54-373 SAS01T to SAS03T Replacement Information

TSB-54-373-FTL

Creation Date: 2025-02-04

- ▶ 108SD Plus/114SD Plus
- ▶ Business Class M2-Plus
- ▶ eM2
- ▶ eCascadia
- ▶ Cascadia

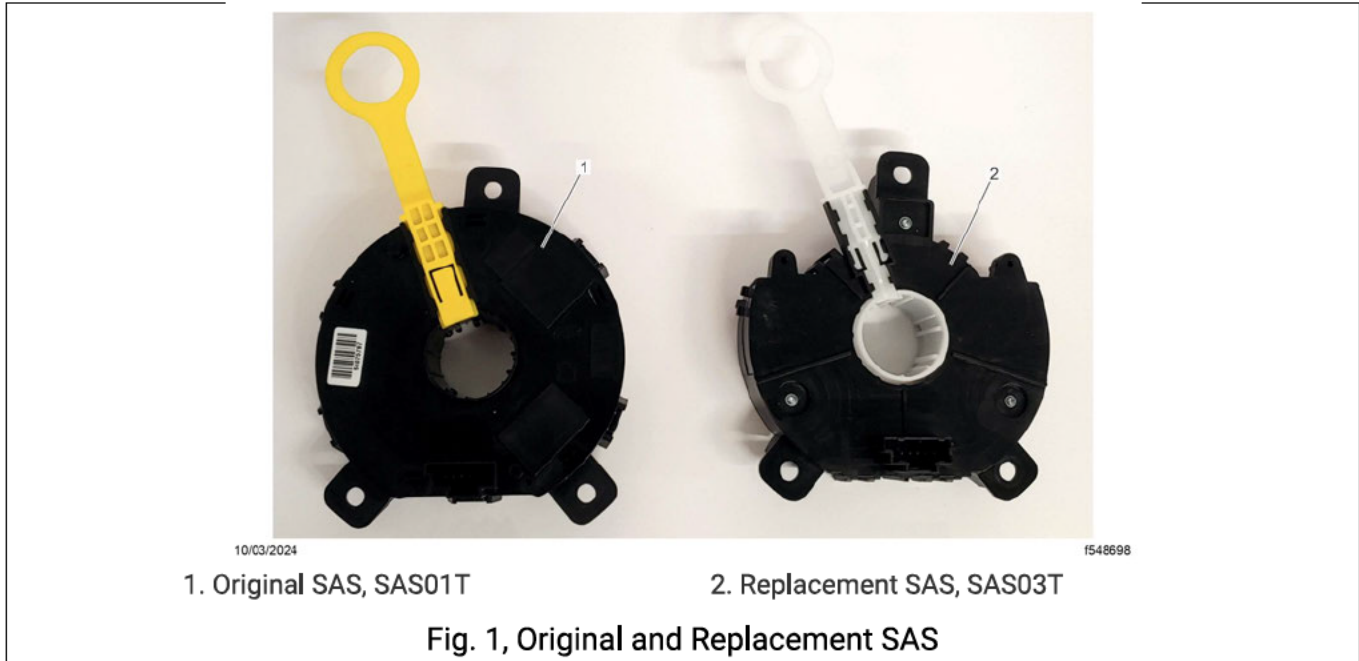
When the Steering Angle Sensor (SAS) model SAS01T runs out of stock, it is substituted with the SAS03T model. The SAS03T is designed to be mounted in the same manner as the SAS01T. However, depending on the software package of the vehicle, changing from SAS01T to SAS03T could result in the activation of fault code 'SA 23 SPN 523021/FMI 31 - The list of Electronic Control Units (ECUs) stored in the Warning Database (WDB) does not match the list of ECUs parameterized in PID 0x20.' Due to the possibility of the fault code being activated, the parts listed in Table 1 cannot be directly superseded.

The SAS03T appears slightly different compared to the SAS01T as shown in Fig. 1. However, the process of replacing and mounting the SAS remains the same. For instructions, see **Group 20** of the applicable workshop manual.

When replacing the original SAS01T, see Table 1 to find the new replacement part SAS03T.

Chassis CAN Baud Rate	Original Part Number (SAS01T)	Replacement Part Number (SAS03T)
500kb Chassis CAN	A14-19418-000	A14-21040-307

667kb Chassis CAN	A14-20044-000	A14-21040-106
----------------------	---------------	---------------

Fig. 4, Setting the Diagnostics Parameter Value

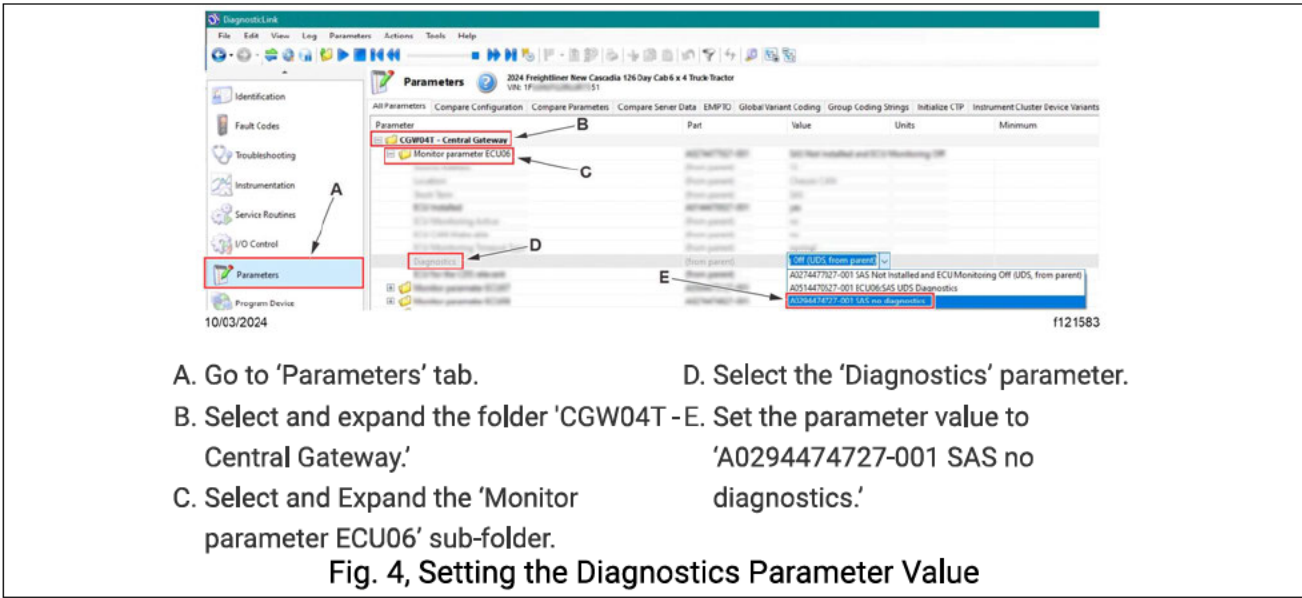
8. Go to the 'Parameters' tab, then select and expand the 'CGW04T - Central Gateway' parameter folder. See Fig. 4.

9. Select and expand the 'Monitor parameter ECU06' parameter sub-folder. See Fig. 4.

10. Select the 'Diagnostics' parameter, and set the parameter value to 'A0294474727-001 SAS no diagnostics.' See Fig. 4.

- A. Go to 'Parameters' tab.
- B. Select and expand the folder 'CGW04T - Central Gateway.'
- C. Select and Expand the 'Monitor parameter ECU06' sub-folder.
- D. Select the 'Diagnostics' parameter.
- E. Set the parameter value to 'A0294474727-001 SAS no diagnostics.'
